Cree® XLamp® Product Change Notification

Customer Name: XM-L2, XP-G2, XP-L customers PCN Reference Number: CREE-PCN-0863

Date Issued: August 27, 2019

XM-L2

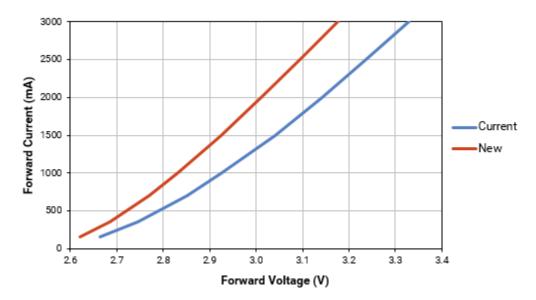
Cree will be changing the typical forward voltage and temperature coefficient of voltage characteristics for XM-L2, XP-G2 and XP-L LEDs. Table 2 shows the current and new values.

The following graphs show the improved Forward Voltage vs. Current curves.

XM-L2		XP-G2 Standard		XP-L	
	Current	New	Current	New	Current	New
Forward voltage	2.85 V @700 mA, 85 °C	2.77 V @700 mA, 85 °C	2.8 V @350 mA, 85 °C	2.74 V @350 mA, 85 °C	2.95 V @1050 mA, 85 °C	2.84 V @1050 mA, 85 °C
Temperature coefficient of voltage	-1.6 mV/°C	-1.4 mV/°C	-1.8 mV/°C	-1.4 mV/°C	-2 mV/°C	-1.4 mV/°C
